Council assessment of Clause 4.6 request

1 Visual representation of height offset

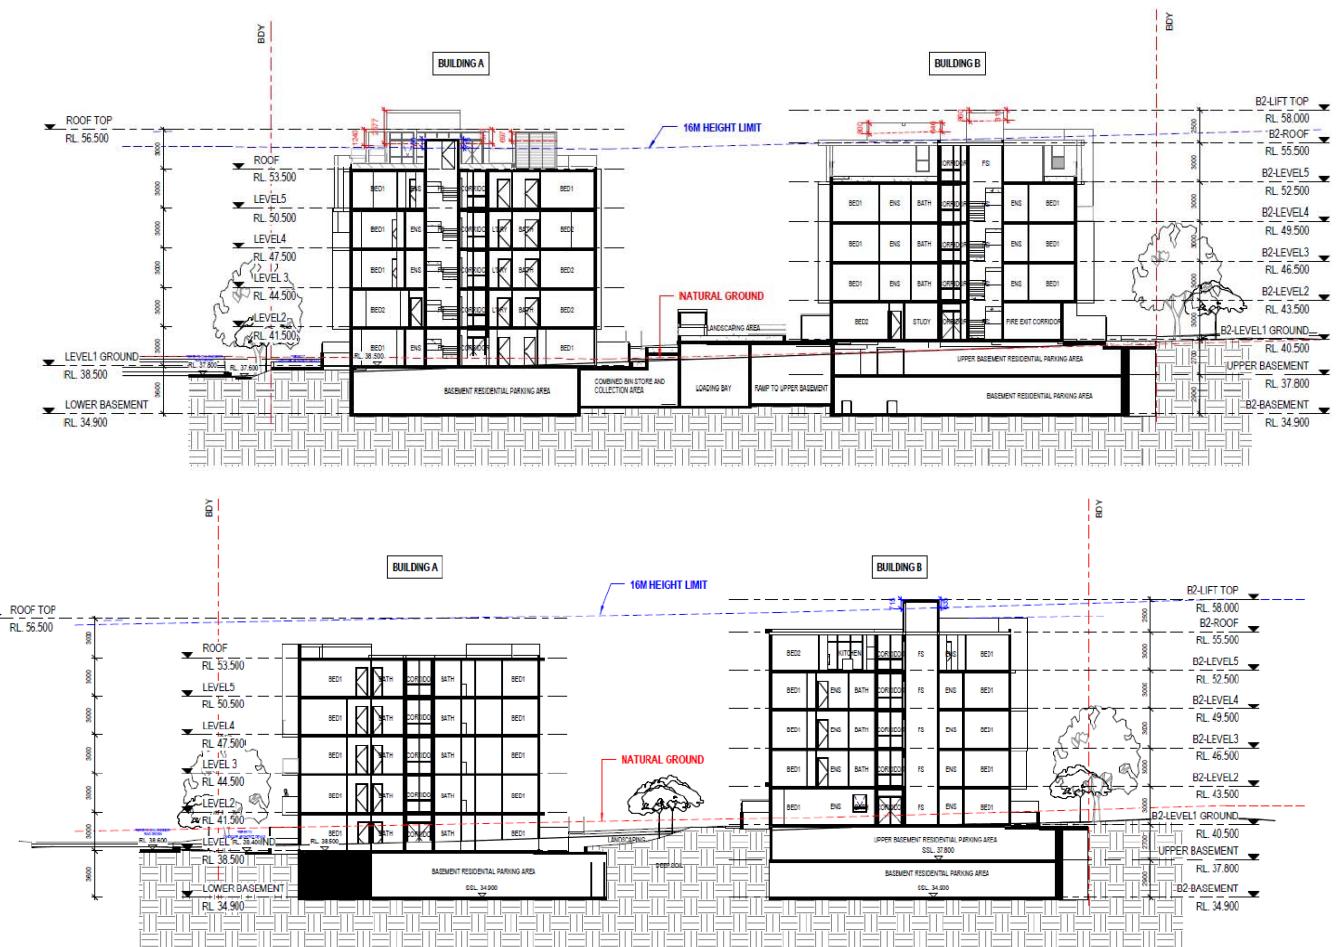
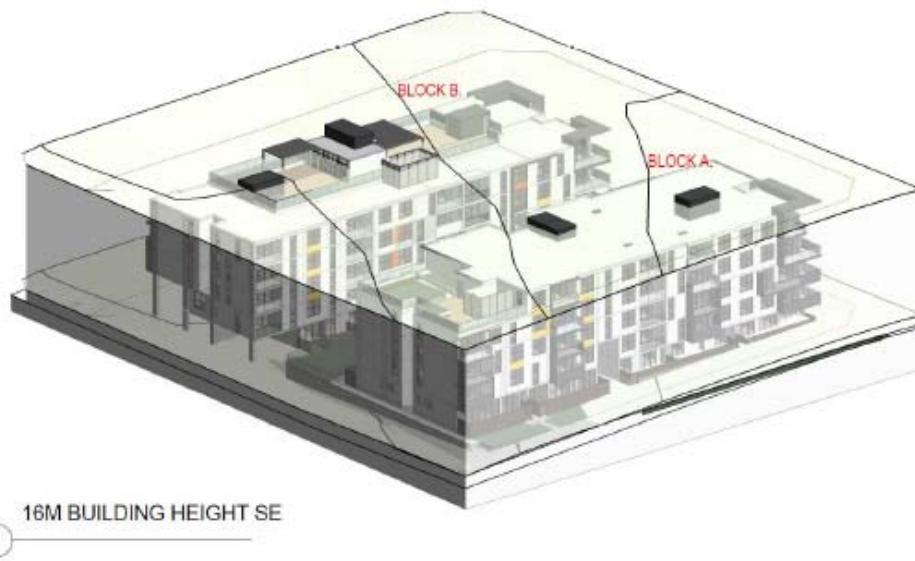
1.1 The following figures identify the portions of the development that exceed the height limit and the portions of the development that are below the height limit.

The maximum height limit on the site is 16 m. Although the development exceeds the permissible height by up to 2.577 m, the development does not achieve an additional residential level. The increase in height therefore does not impact on the density / floor area of the development. The increased height also has no impact on the scale of the development. The additional height simply accommodates the roof structure and rooftop services.

The additional shadow impacts are negligible. The overshadowing caused by the non-compliance is due to the rooftop plant and equipment which is captured within the roof space itself.

Based on the above assessment, the requested variation under Clause 4.6 is considered reasonable, well founded and is recommended for support.
